WSP USA has reviewed the submittal and returns it with the status "Reviewed as Noted". Resubmission is not required unless significant changes result from the review comments.

SUSPENDED PLATFORM SYSTEM DESIGN

THE MIDDLESEX CORPORATION			
CONNECTICUT DEPARTMENT OF TRANSPORTATION CONTRACT No. 92-522 ROUTE I-95 over WEST RIVER SUSPENDED PLATFORM INSTALLATION PLAN PLAN VIEW & ELEVATION			
CDI JOB NO. 17-11	DATE 2-14-17	DWG. NO. PL-1	1

THE MIDDLESEX CORPORATION
 CONNECTICUT DEPARTMENT OF TRANSPORTATION
 CONTRACT No. 92-522
 ROUTE I-95 over WEST RIVER
SUSPENDED PLATFORM INSTALLATION PLAN
DETAILS

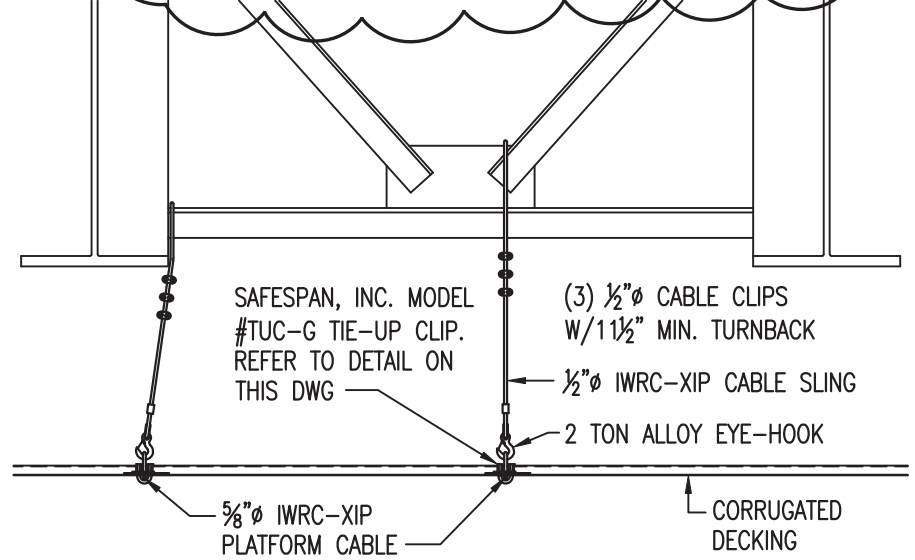
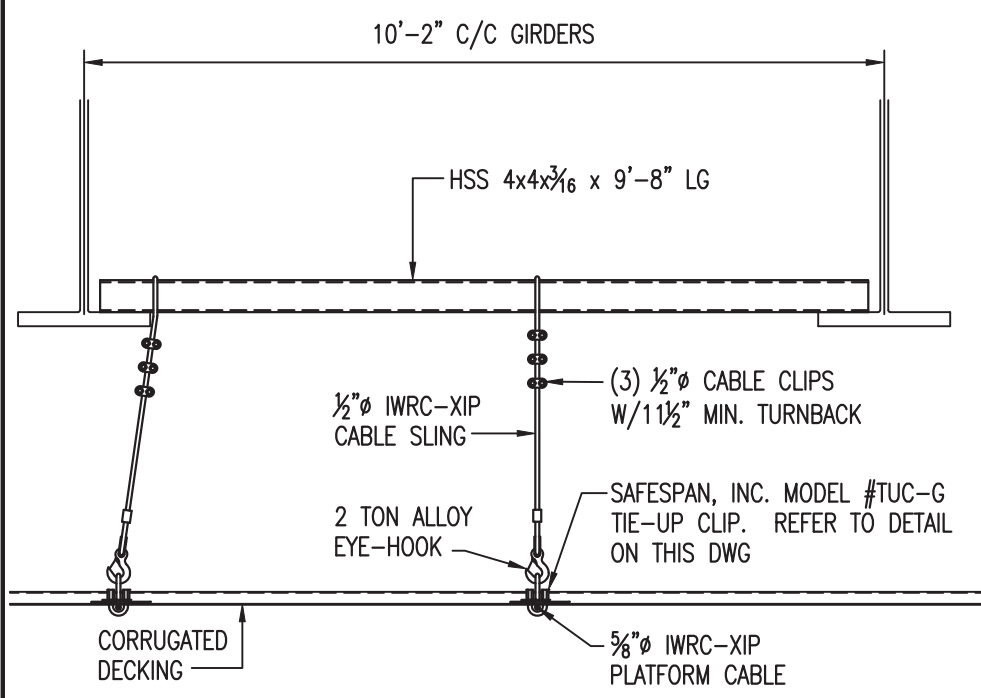
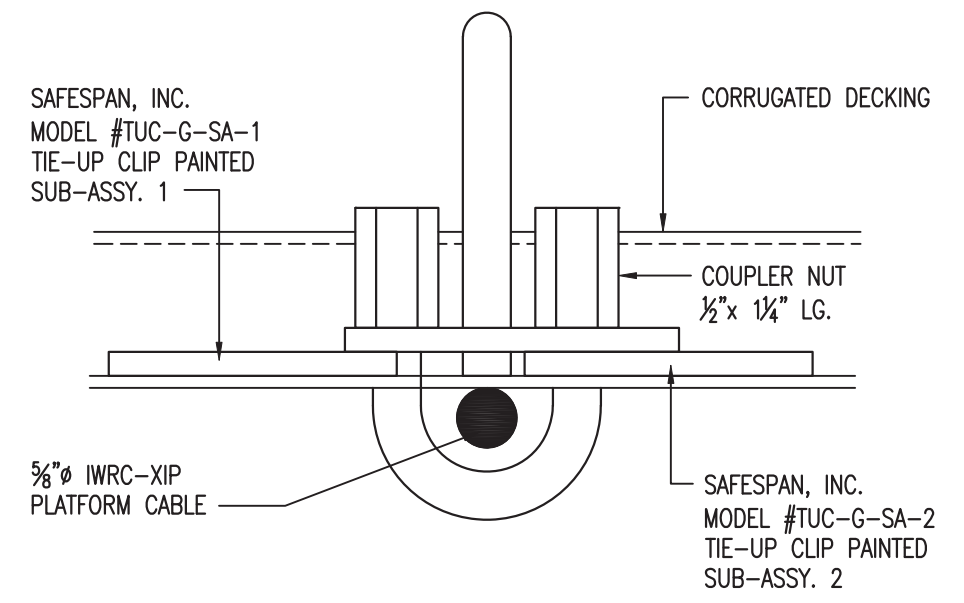
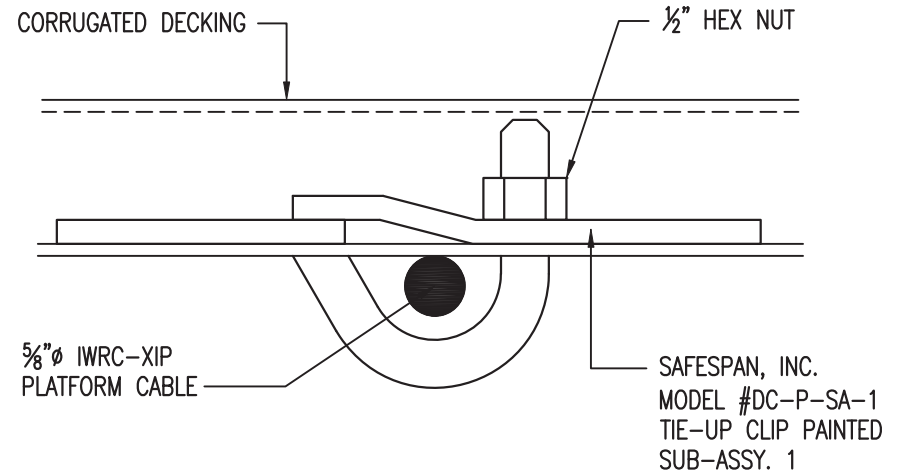
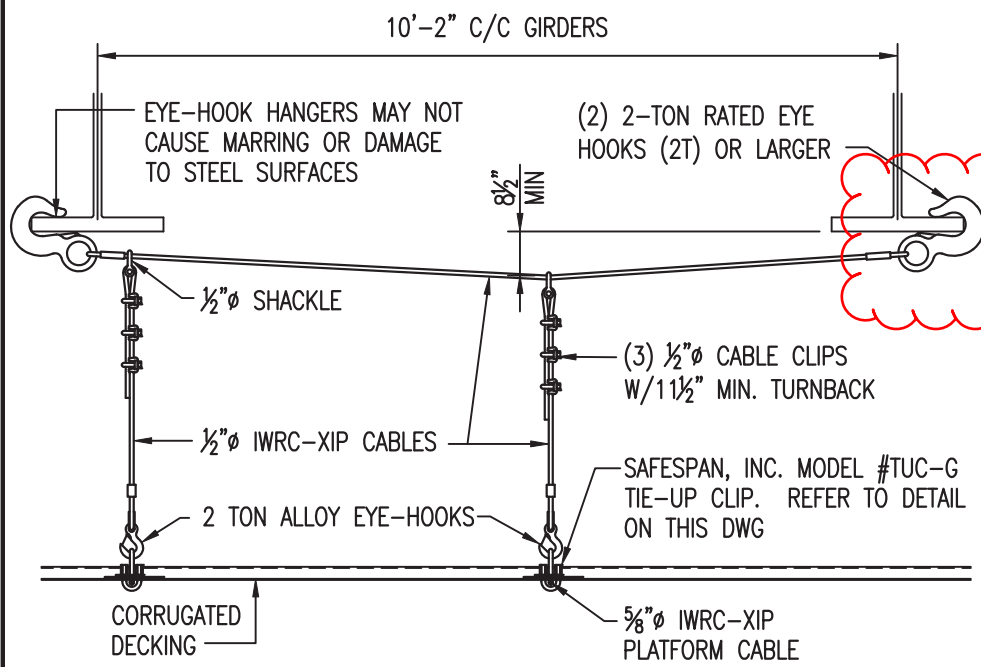
VERIFY THAT CONTRACTOR WILL REPAIR ANY DAMAGES TO THE FLANGES AND/OR PAINT FINISH DUE TO THE HANGERS.
